ANOKA COUNTY

COUNTY DITCH INSPECTION REPORT

DITCH # 28

From: Jon Olson
To: Sabatka, Dan
Date: 7/16/04 3:21PM
Subject: Classic Construction Proj No 2004-157K

CO-DIT #28

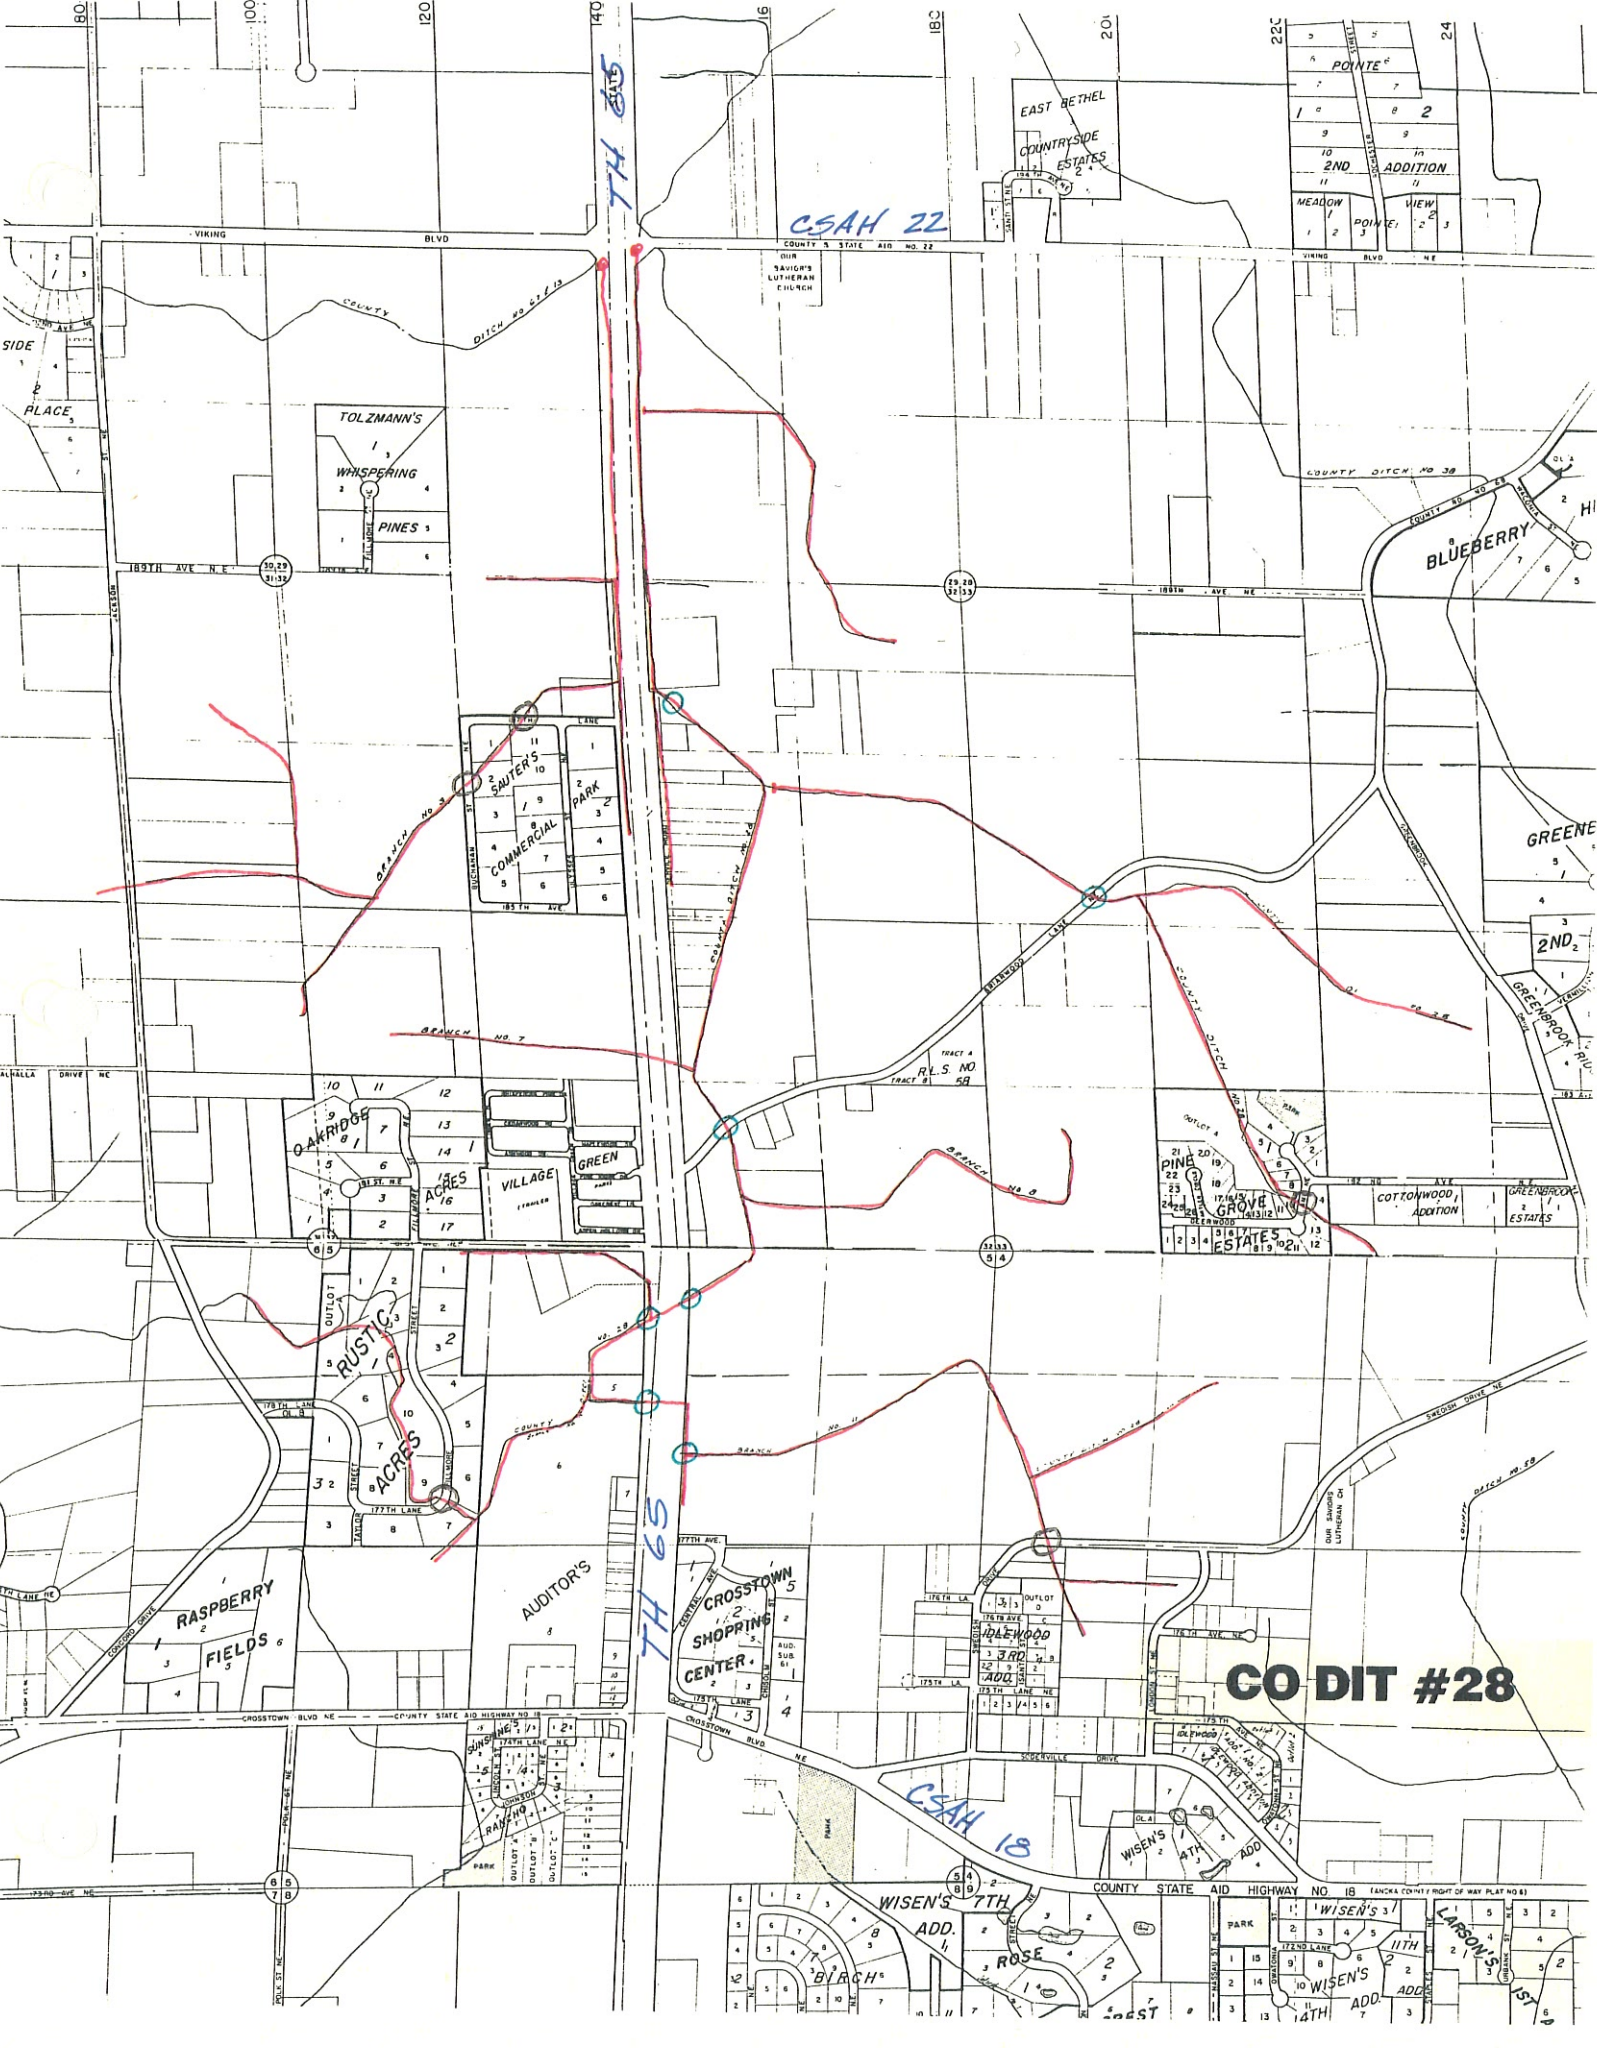
- W Serv Rd TH65 (So.) Ditch defined, no apparent flow.
- W. Serv. Rd. TH65 (No.) Ditch defined, no flow apparent.
- ↓ TH65 (N.B.) (So.) Ditch to east defined. Beaver dam 100' east of R/W.
⊛ No apparent flow from east.
- ↓ TH65 (N.B.) (No.) Ditch well defined, trees lying across ditch. Slow flow to east.
- ↓ Briarwood (W) Ditch well defined & flowing. Culvert @ this crossing proposed for repl. in 1994 on East Bethel Str. Proj. (Tabled.)
- ✓ Entr. Antiques of Meadowmoor Ditch flowing & defined.
- Briarwood (E) Ditch defined on south side of road, but grown over with brush. No apparent flow.

⊛ East TH65 road ditch connects ditches.

Marshy area, ditch not defined.

Ditch defined, no apparent flow. Overgrown with canary grass away from street.

Ditch defined & flowing.

Ditch defined & flowing.

Ditch defined & clear.
No apparent flow.
